### MAS004276 RU 24-21

# Rapid Update 728 Granturismo & GranCabrio BEV –front axle screws Replacement

DATE: JULY 15, 2024

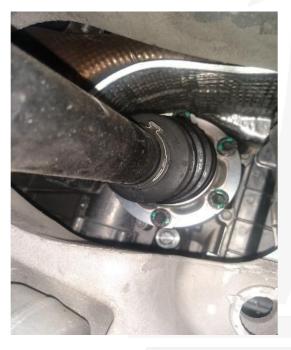
3. Identify the area of the joint to be checked and check that there are no obvious traces of grease/oil, paying particular attention to the area under the head of the screws, external diameter of the joint and ends of the screws beyond the flange.

- 4. Carefully clean the interface area, including the half-shaft holes, then replace all the screws and plates following the procedure given in the workshop manual from point 15.
- 5. 03.22.002 COMPLETE FRONT HALF SHAFT RIGHT Removal/refitting replacement

- 6. Complete the replacement of the components (screws and plates) of both axles, right and
- 7. **Note**: If oil contamination is found from the joint, it will be necessary to open a BOL report to obtain additional information on the type of intervention to be carried out.
- 8. Restore any disassembled components by following the procedure in reverse order.
- 9. Procedure complete.
